Service Bulletin

SB1-06

SUBJECT: Removal of pin #2 on SS1001 SlickSTART™ ignition boosters.

Figure 1

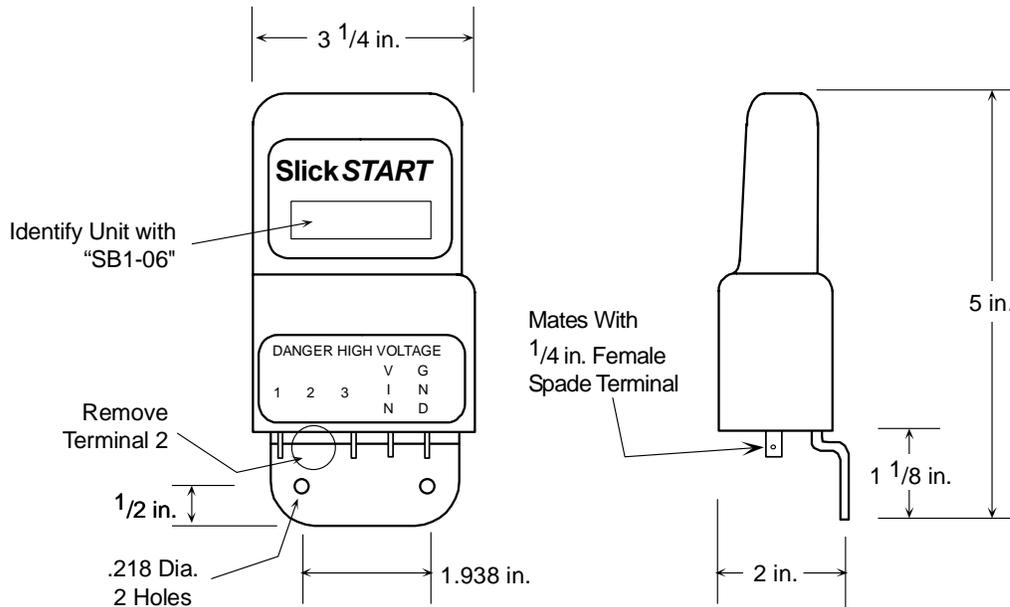
2. If the SlickSTART™ unit is accessible, cut of the #2 pin as short as possible to prevent future use of this pin. See Figure 1. If necessary, remove the SS1001 from the firewall to complete this operation then re-install it.

Figure 2

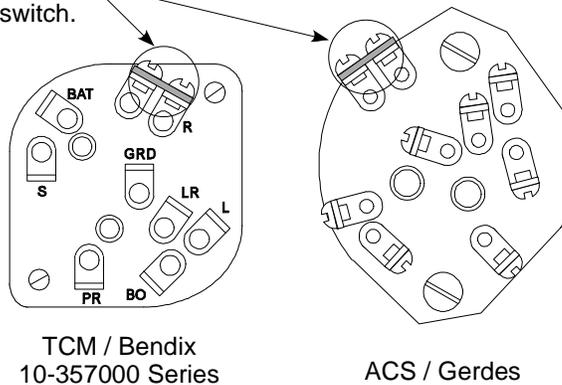
- A. In most applications, the right magneto can be grounded during start by the ignition switch. If the wiring connections on the back of the ignition switch are similar to those shown in Figure 2, a jumper can be added to the two terminals shown to provide a ground path during start.

Verify that this jumper is installed if your aircraft is equipped with this type of switch.
